Roof Plan

For:		Job:	
Mr. N. Minter.		49 Redhoods Way West, Letchworth	
		Title:	
		Proposed Roof Plan	
Scale:		Date:	
1:50 @ A3		Nov 2024	
Dwg No:		NWM / 2023 / P7	
		Rev:	
		A

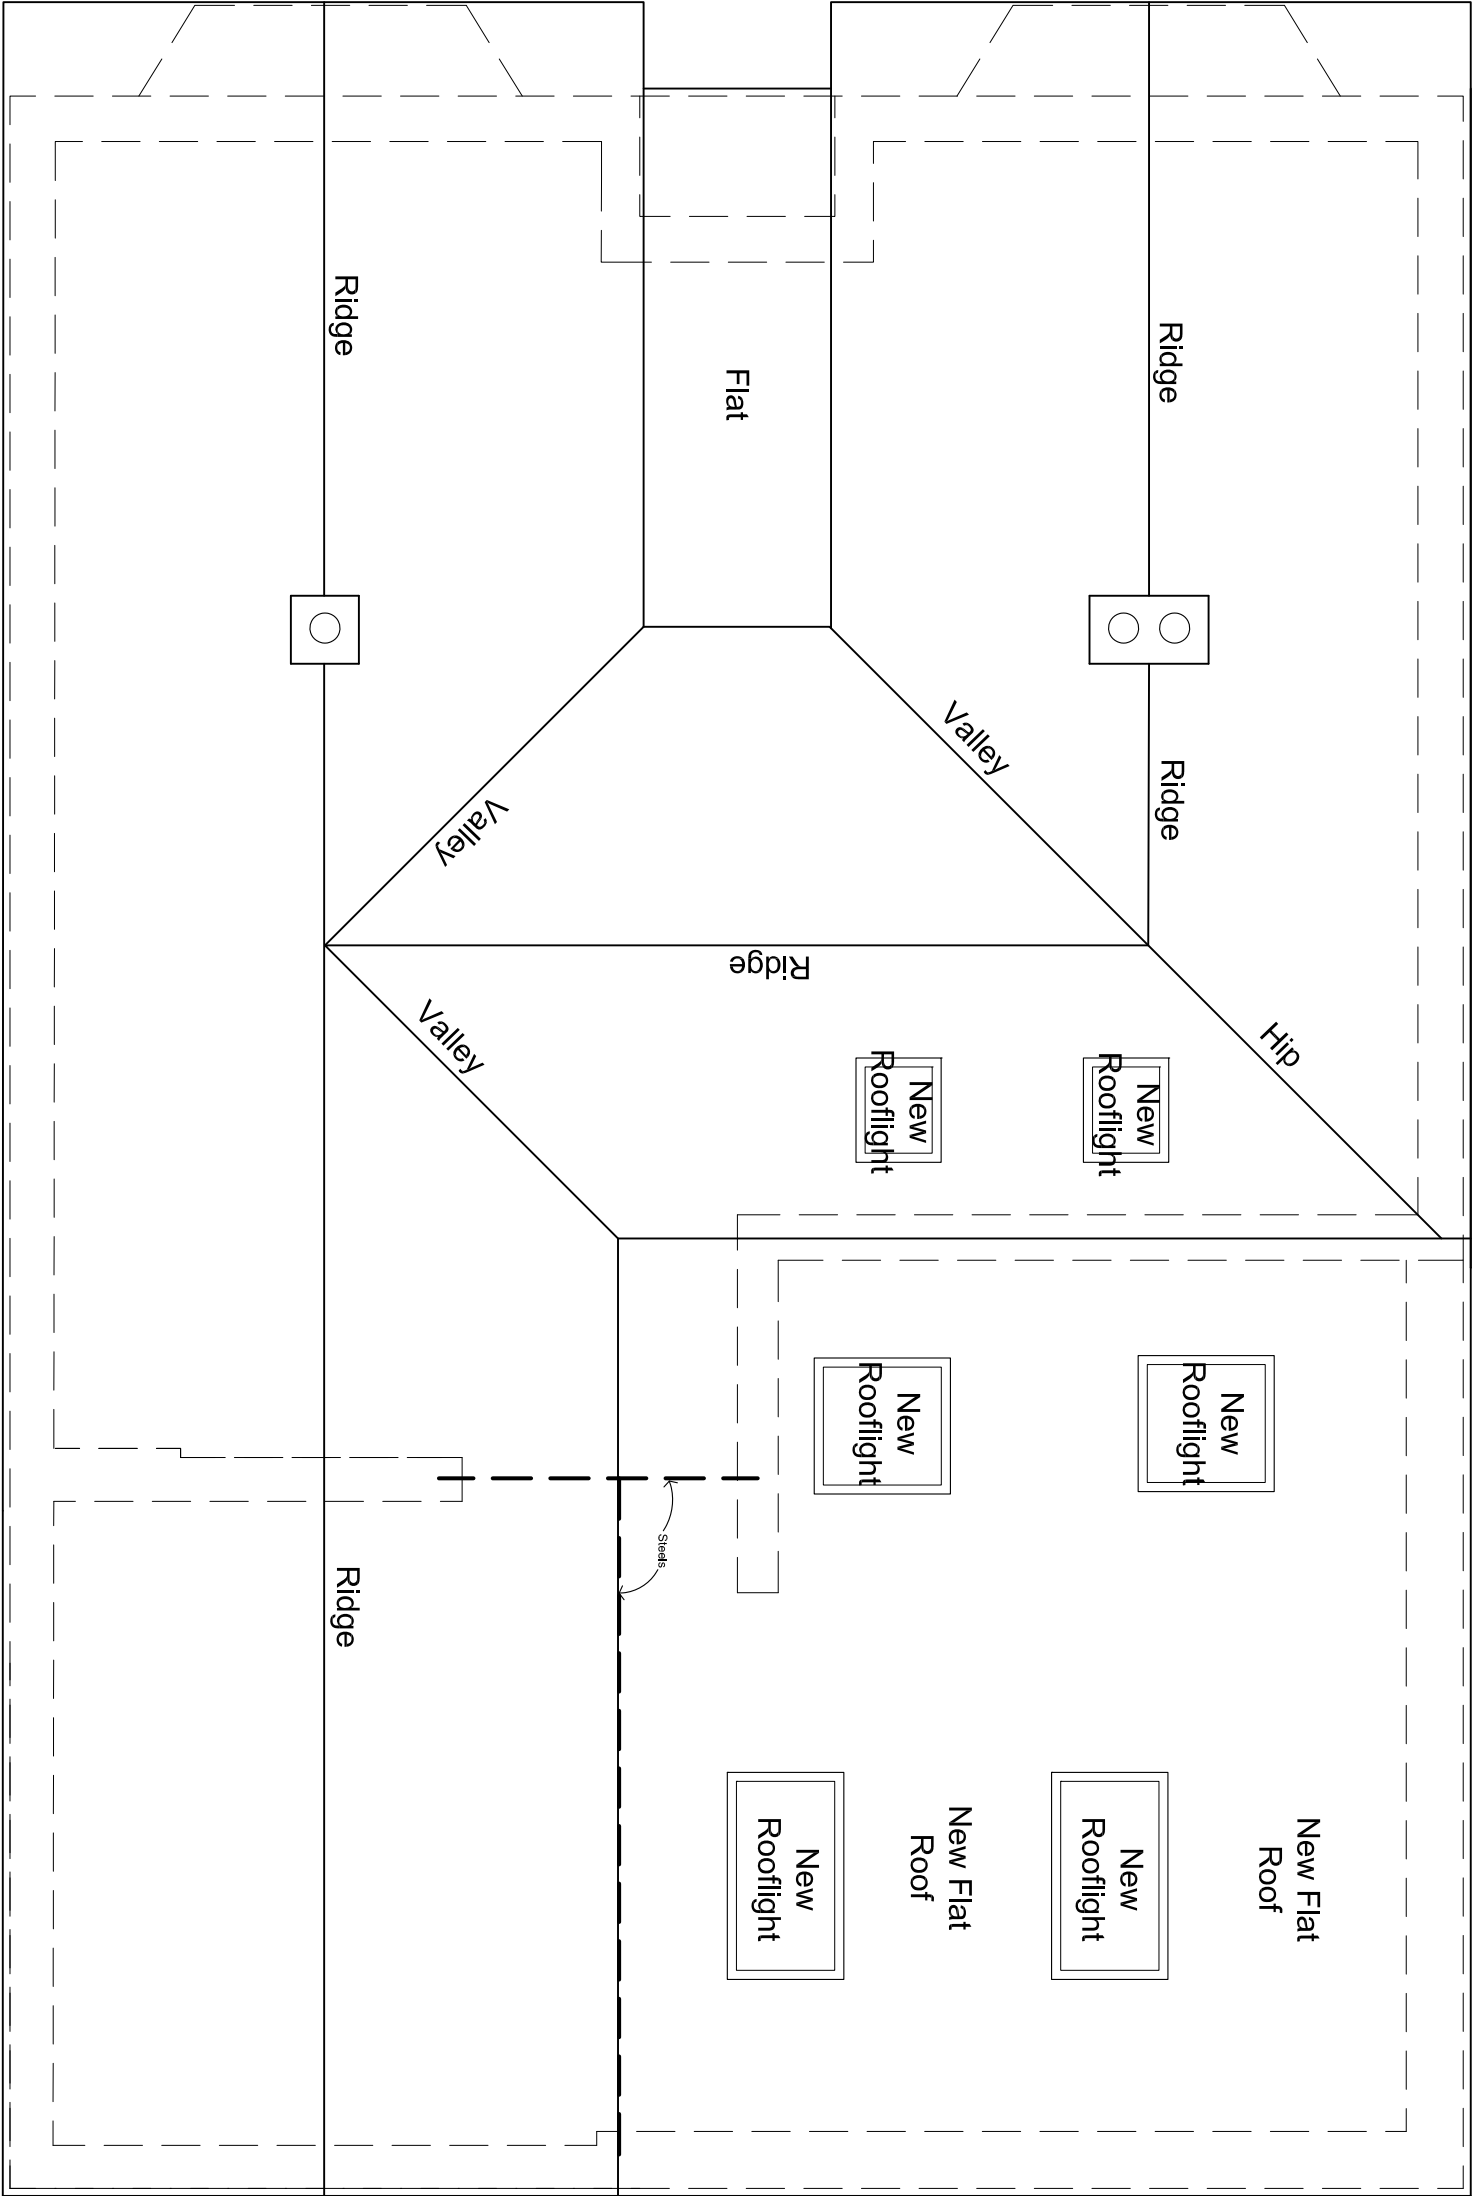
REVISIONS: Nov. 2024: Drawing revised to show existing (pitched roof) rear extension retained with proposed extension reduced in size to fill in the North East corner.
